**Re: *Pioneer Valley Energy Center, Westfield, Massachusetts
Prevention of Significant Deterioration Air Permit Application
Information Request Response
ESS Project Number E402-007.01***

On behalf of Pioneer Valley Energy Center, LLC (PVEC), ESS Group Inc (ESS) is providing the following supplemental information to the above referenced application in response to your request for additional information dated May 17, 2011.

Figure
1A

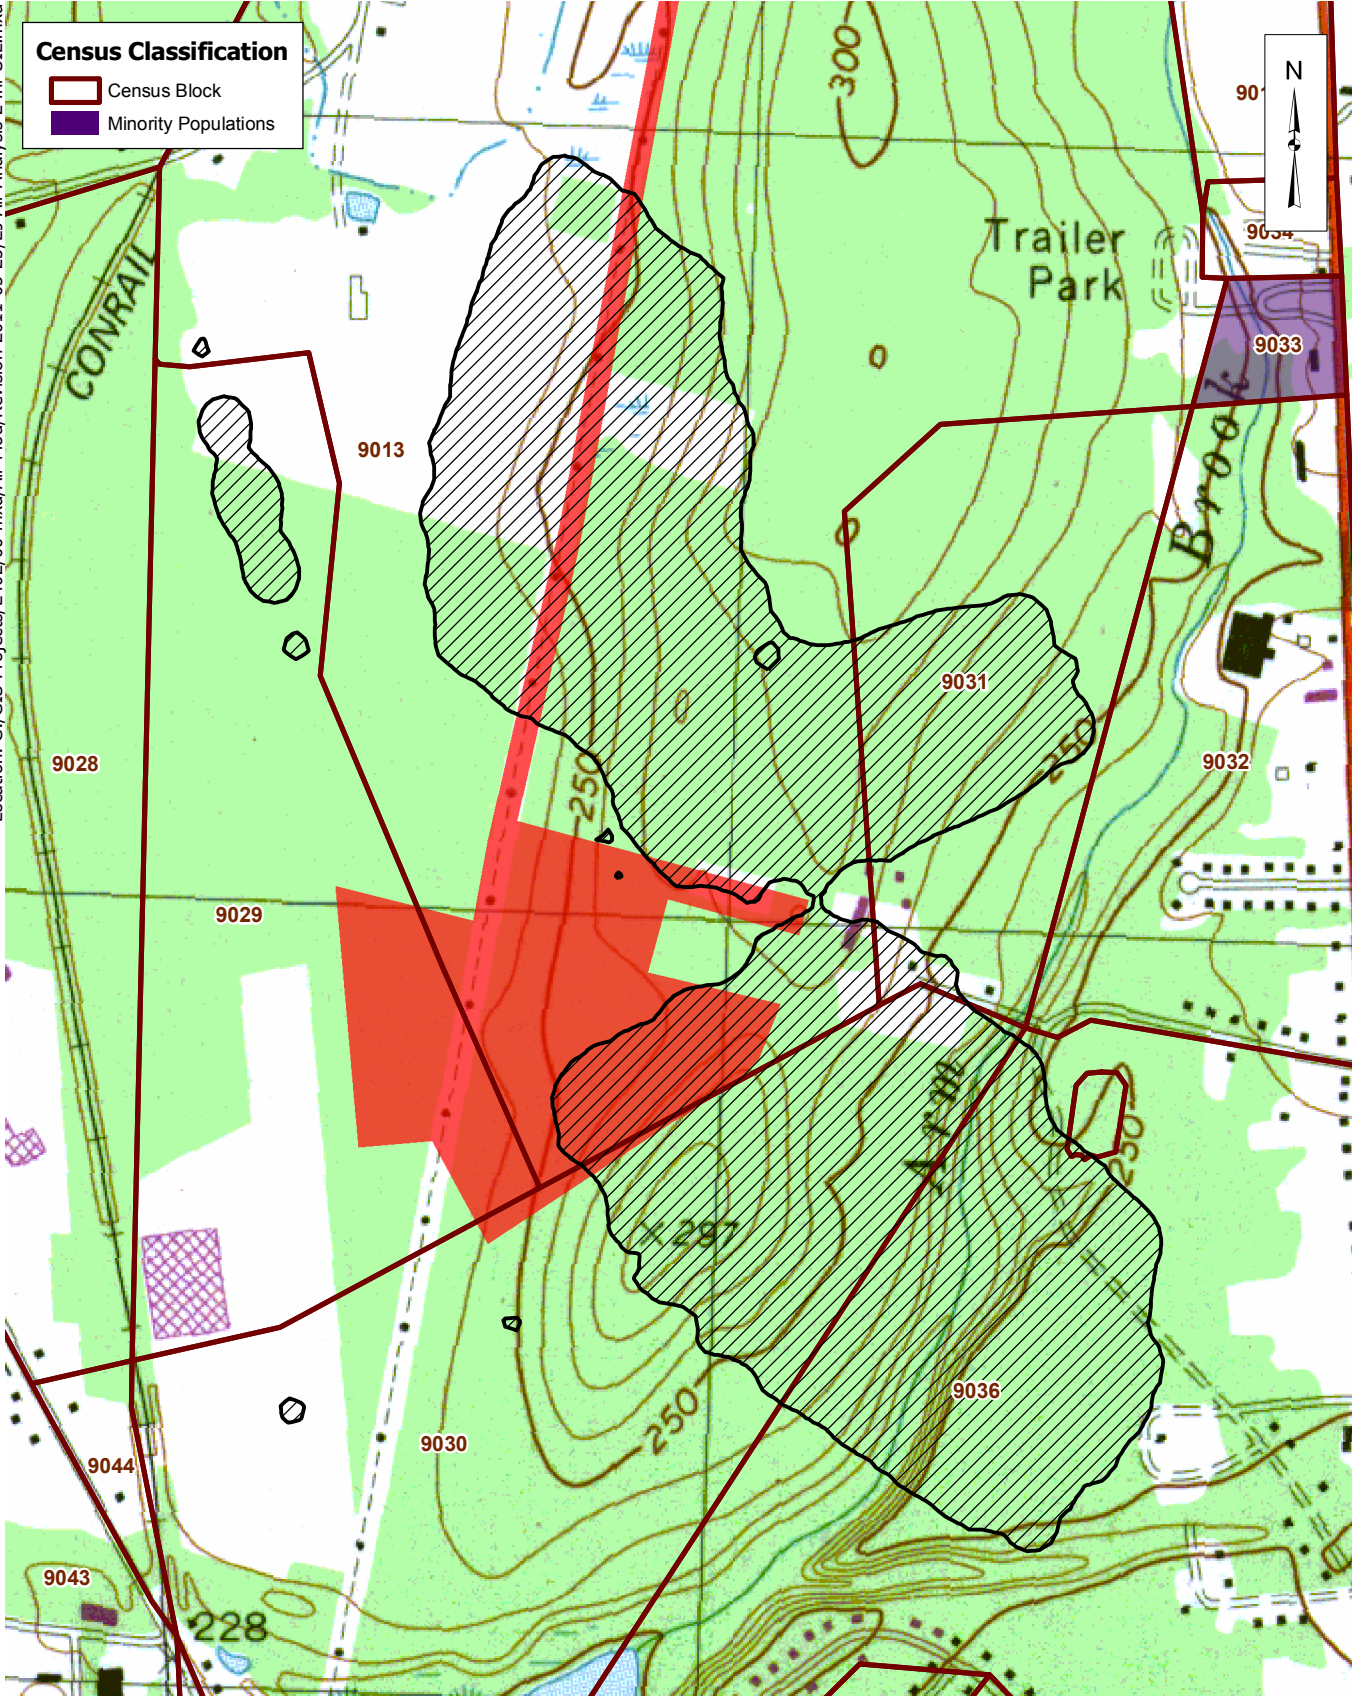
1. The EPA has requested that PVEC provide figures which magnify the significant impact areas (SIA) for annual and 24-hour PM_{2.5}. The attached figures (Figures 1A and 2A) provide such detail. As shown on Figures 1A and 2A, neither the SIA for annual nor 24-hour PM_{2.5} include any identified environmental justice areas.
